SUBJECT: Litchfield Municipal Airport

Illinois Project Number: 3LF-5221 SBG Project Number: 3-17-SBGP-TBD

Addendum A

Adjustment to building foundation detail/notes.

NEW VAULT BUILDING GENERAL NOTES

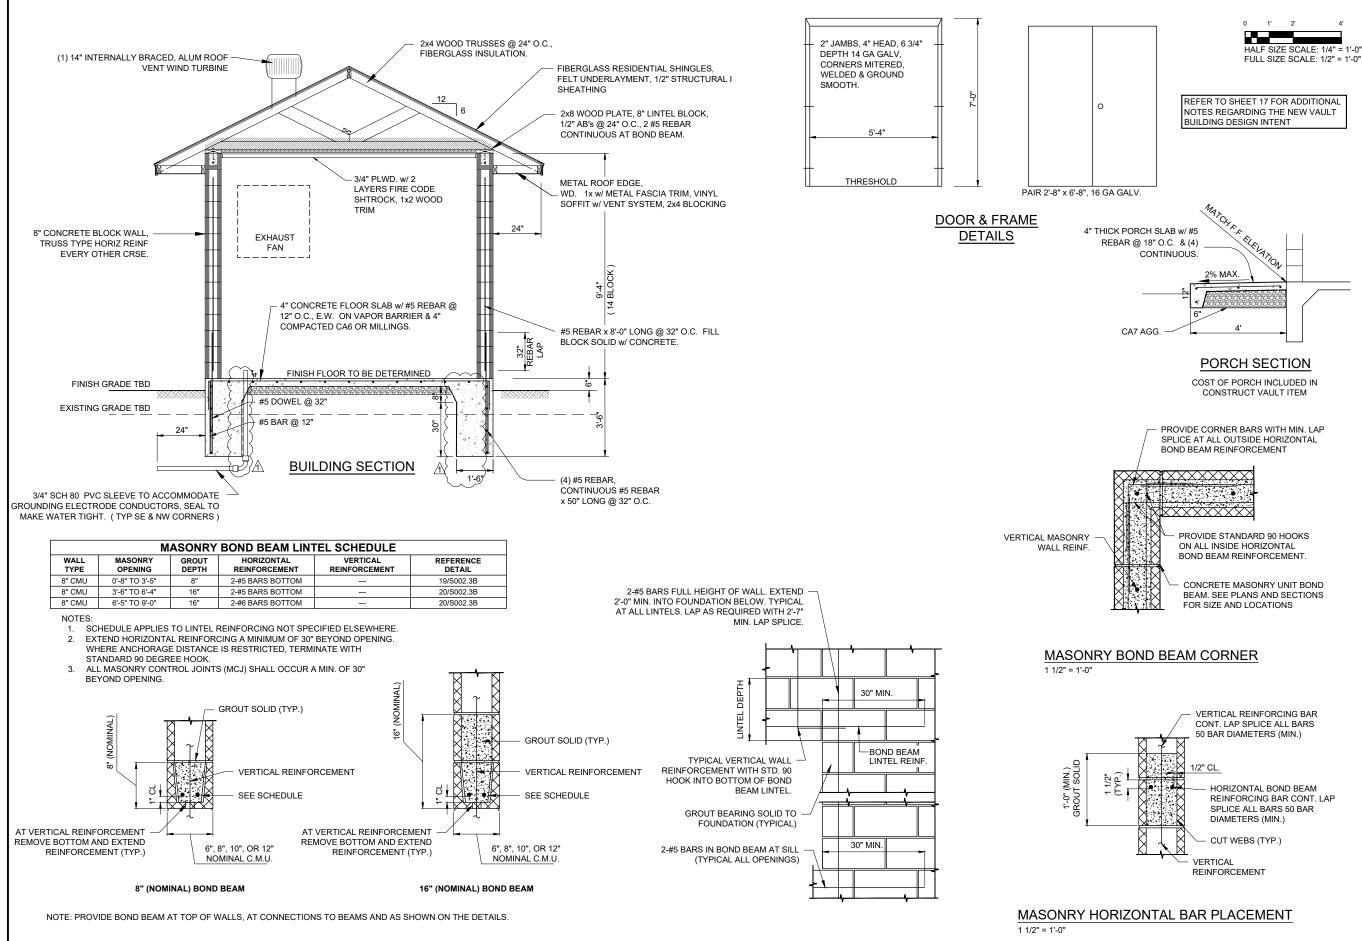
Plan Sheet 13, New Vault Building General Notes:

Revise Foundation Note F-1, see attached revised plan sheet dated 10/28/25.

F-1. NET ALLOWABLE SOIL BEARING PRESSURE - 2000 PSF PER MET, INC. SUBSURFACE EXPLORATION AND FOUNDATION RECOMMENDATION REPORT DATED OCTOBER 16, 2025.
